# **Deadline 7 Submission on Behalf of the Neighbours and Users of Queen Elizabeth Park**

**Nick Jarman**

Interested Party reference no: **20022545**

Corrected tree positions: T562 (sycamore), T487 (beech) and T489 (beech) are not correctly located on Esso's map. Dotted orange lines show the position on Esso's tree survey, solid orange lines show roughly where the trees actually are.

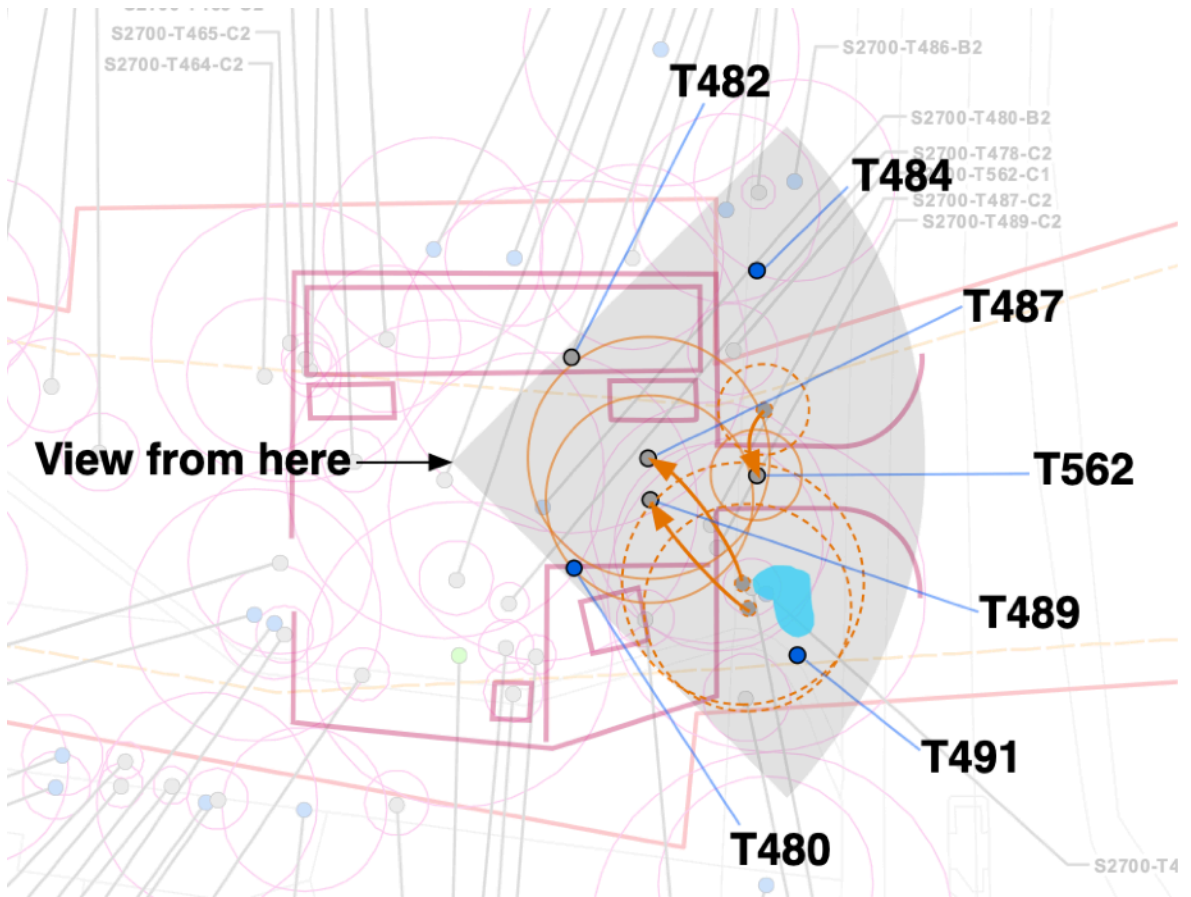
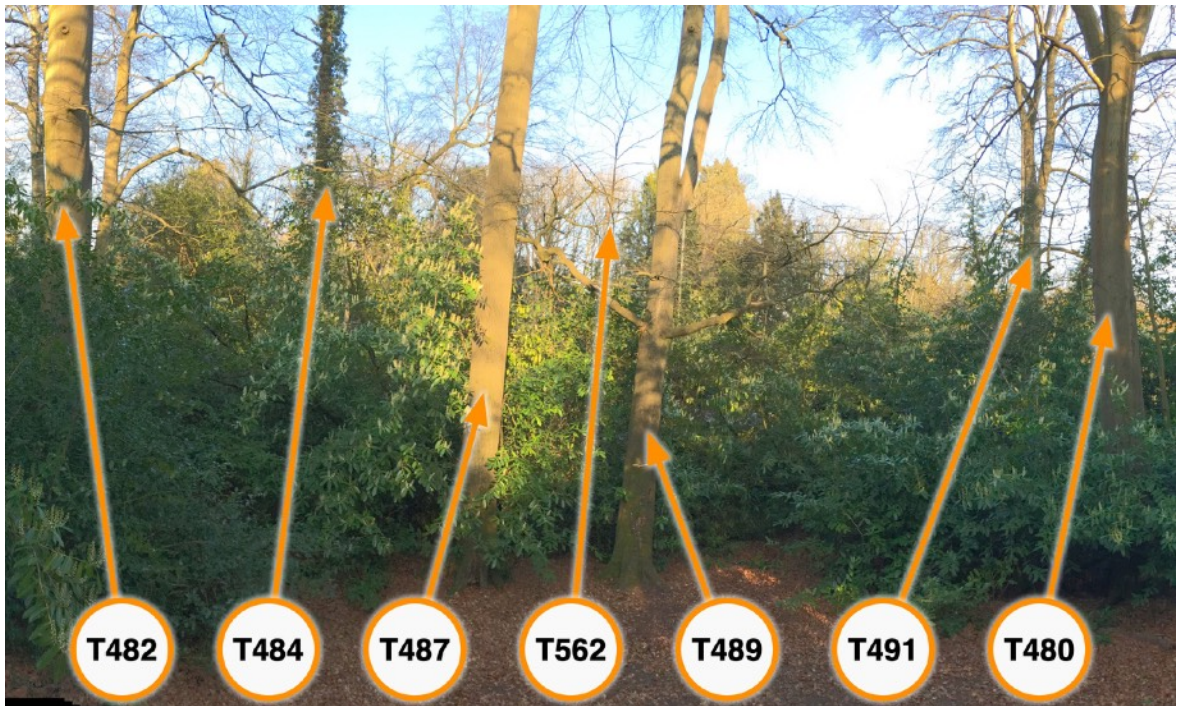
We have concluded that some trees are not shown in the correct place, namely T487, T489 and T562. As evidence of this, we present a photograph taken from a known point, with trees from Esso's survey labelled. It should be evident that Esso's plan cannot possibly be an accurate representation of this view because if it were, T487, T489 would appear almost in line with T491.

Our amendments to the drawing show the more likely positions of these trees. We note that all three trees would obstruct the proposed entrance and access ramp for the compound.

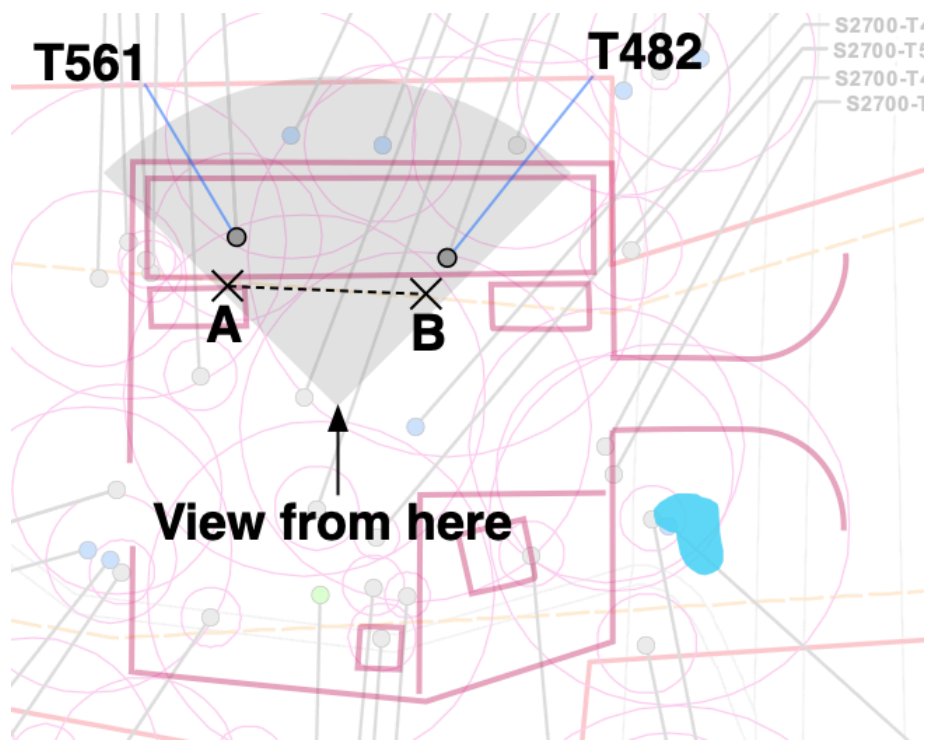
We have also observed that trees T487, T489 and T562, which are shown in the wrong place on Esso's drawings (see section 2.2), will block the path of the proposed ramp, meaning that there is no practical way for vehicles to access this area without the removal of trees which Esso has claimed will be retained.

The drawing and photograph below attempt to give an impression of the gradients within the proposed auger boring compound. The photograph shows the difference in ground levels between points A and B in the plan. This is by no means the steepest gradient in the area but it is the easiest to photograph. The gradient between these points is approximately 24% but there are areas with gradients of 35% and more.

It would have been useful if Esso had submitted a topographical survey of the area to the examination to show that their plans are feasible. In the absence of this information, and with our knowledge of the site, we conclude that the survey has not been provided because it would prove that Esso's plans for this area, with the stated level of tree retention, are not feasible.

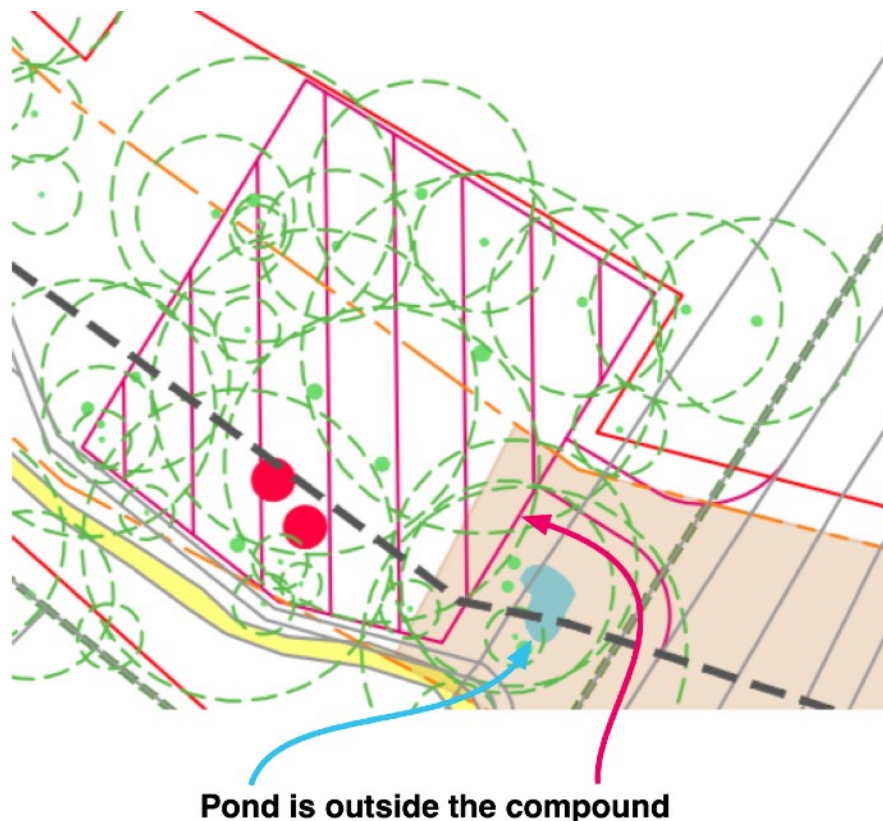
Please refer to the previous section for our comments about getting vehicles and equipment into the area via the proposed ramp.

Note that the pond (blue area) is outside the pink hatched area which the key describes as ‘area for auger boring activities’. This means that the pit would be outside the compound and therefore not protected by being enclosed by it. Furthermore, the compound fencing would prevent machinery from accessing the pit area.

The reasons for enclosing such a large area within the compound, when gradients and tree cover mean it cannot be used for any activities, are unclear. There is no explanation as to why the pit is outside the compound.

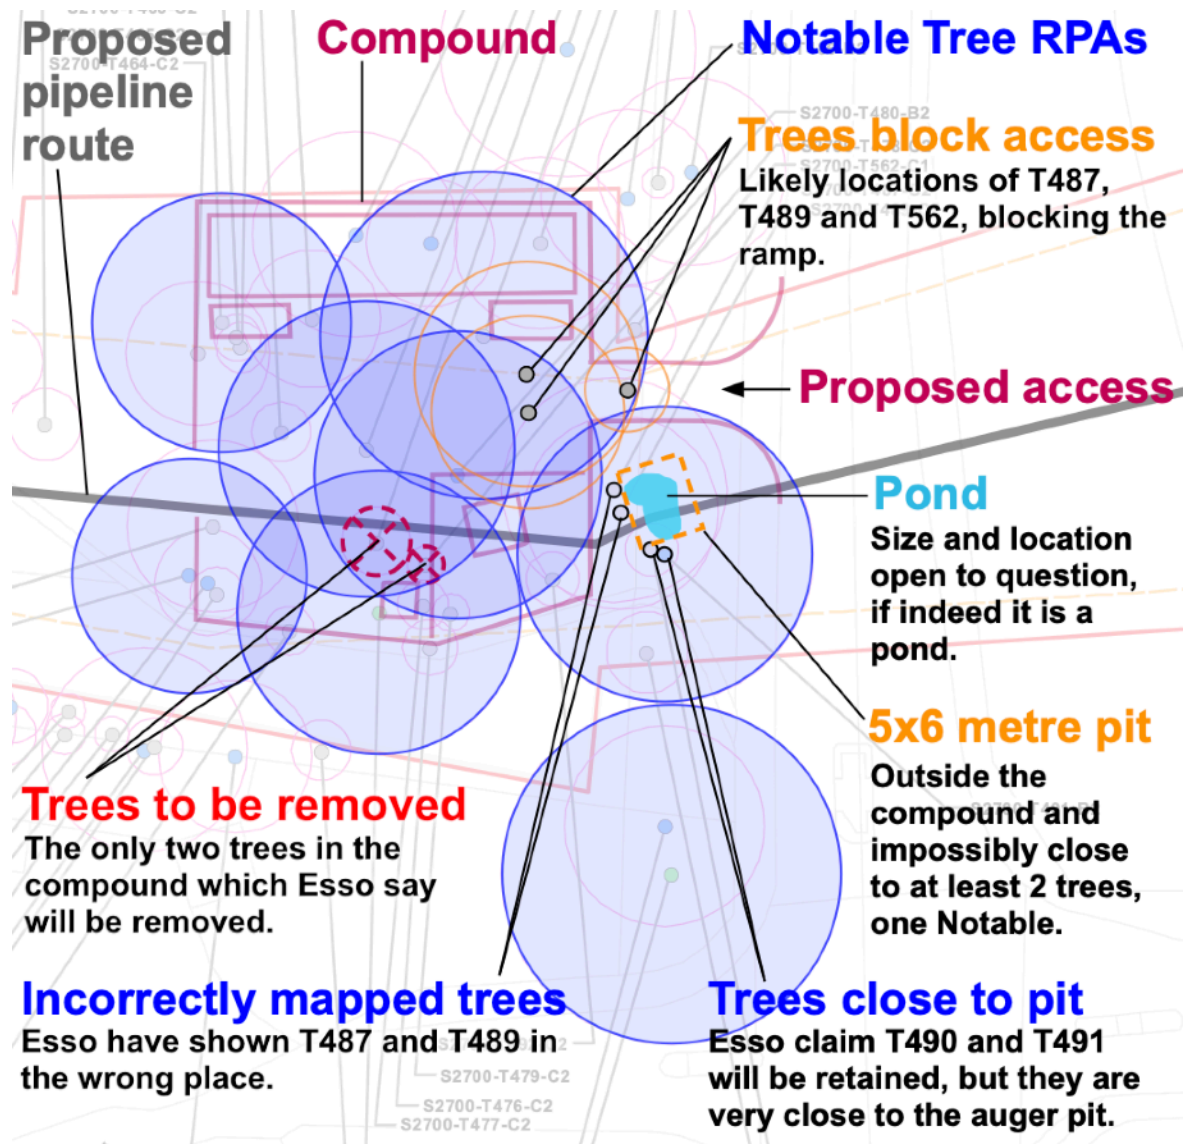
The entire area is still very badly thought out and poorly documented. The information presented by Esso to the Examination does not make sense.

The diagram above is based on the tree survey drawings in the QEP SSP and attempts to show some of the main issues with the plans and proposals provided by Esso.

**Trees or pond are incorrectly positioned in the drawing**

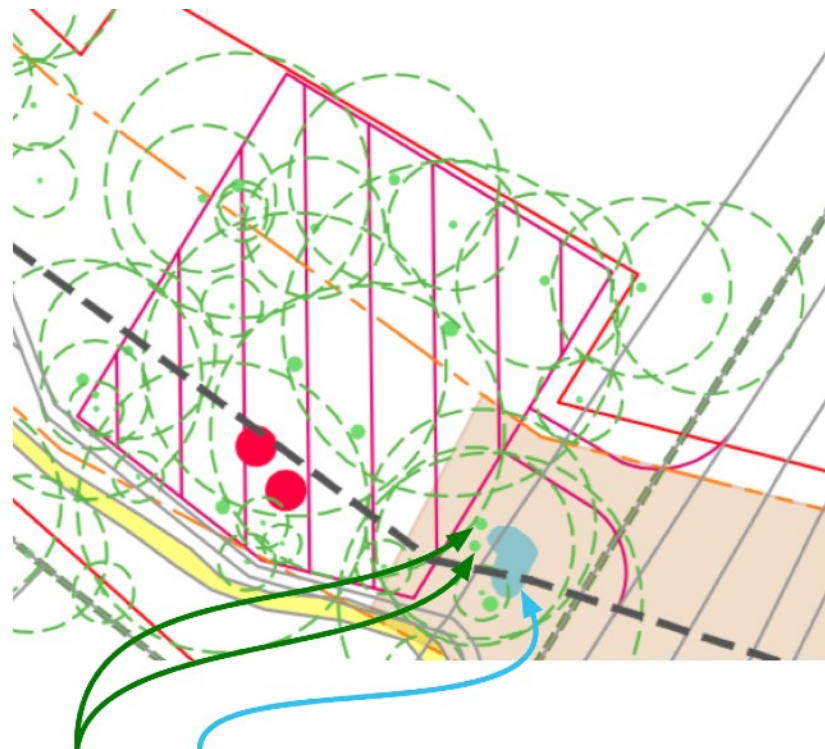
The construction phase drawing in the SSP (extract below) shows the water body/ depression adjacent to T487 and T489 (unlabelled on this drawing but numbers are obtained from the tree survey drawings):

Standing on site and checking this visually, there is no depression or pond adjacent to T487 and T498. Based on this, we believe that not only are the trees drawn in the wrong location (see section 2.2), but the pond/depression is also drawn in the wrong location.

The distinctive oak leaf shape can be seen in the magnifications

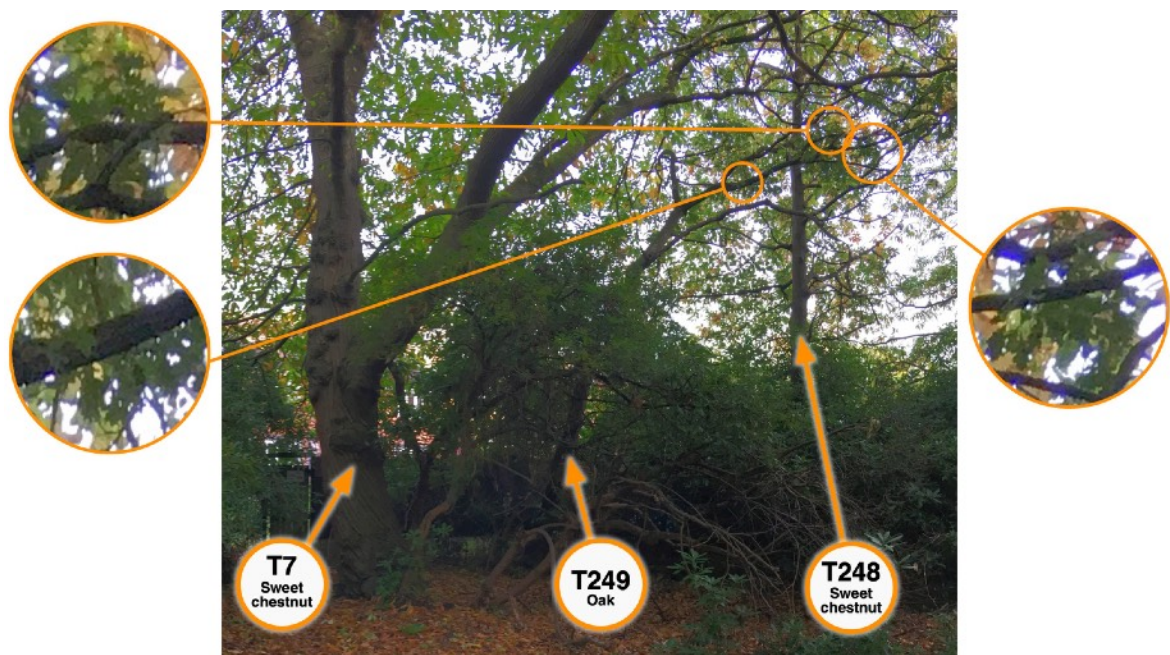
It is difficult to know how best to respond to this. We are extremely familiar with this area of the park. We have also studied Esso's tree survey and drawings in detail to make absolutely certain that we are confident in this assertion: T249 is an Oak.

The photograph below is the only recent picture we can find of T249 when it is in leaf and therefore provably an oak. It was taken in October 2018. We have done the best we can to highlight identifiable oak leaves in the picture but are limited by the low resolution of the picture.

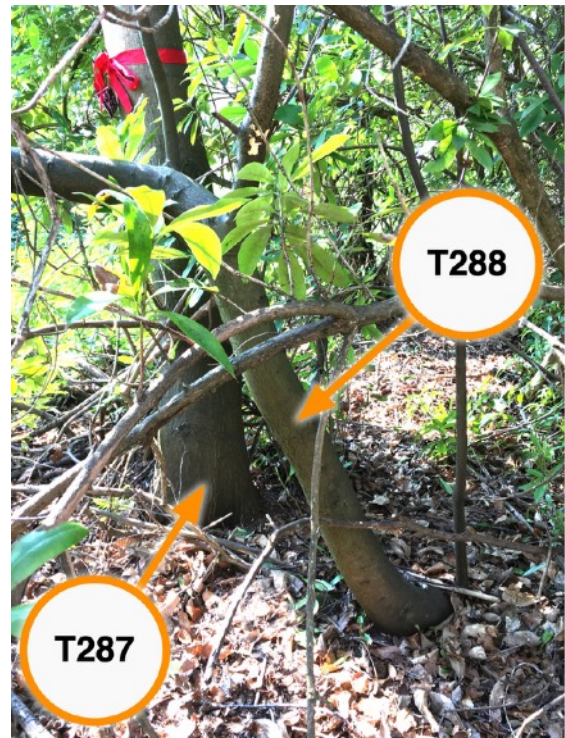
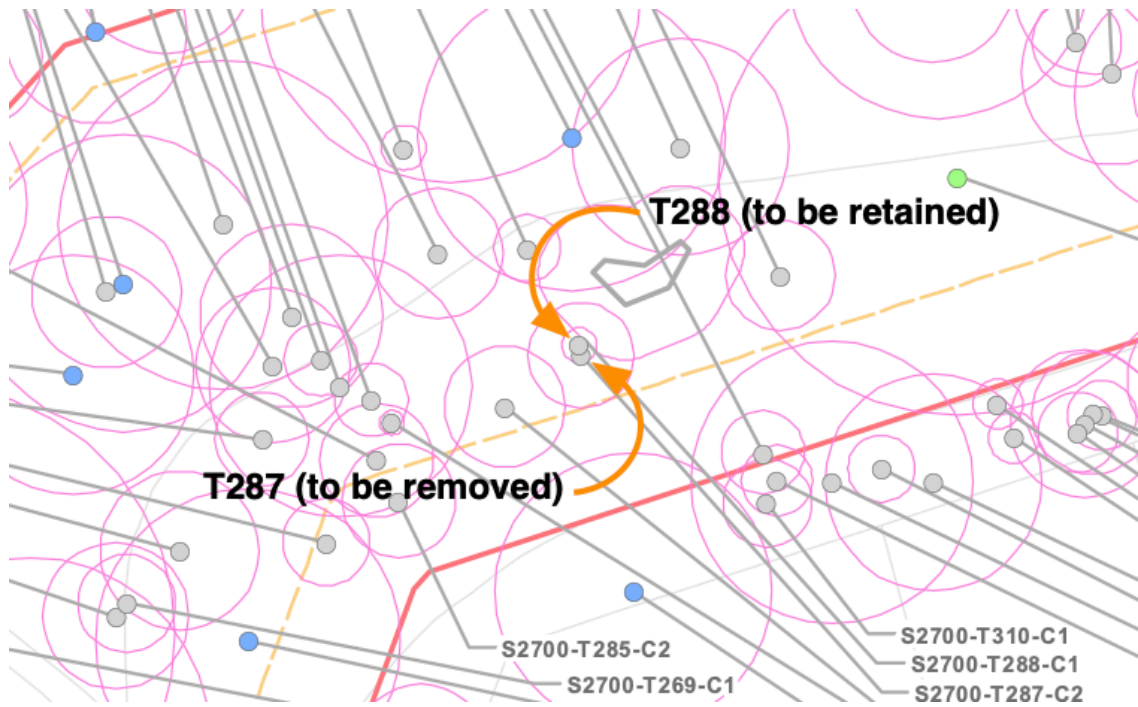
We have doubts about Esso's ability to state so confidently that only those trees which they have listed will be removed. We can show that trees which they claim will be retained are likely to suffer serious damage when their neighbours are removed.

For example, we are somewhat surprised that Esso believe T288 can be retained and not damaged by any works which necessitate the removal of T287 given its proximity to T287. The diagram and photographs below show why this seems hard to believe and leads us to question the commitment on 30 trees.
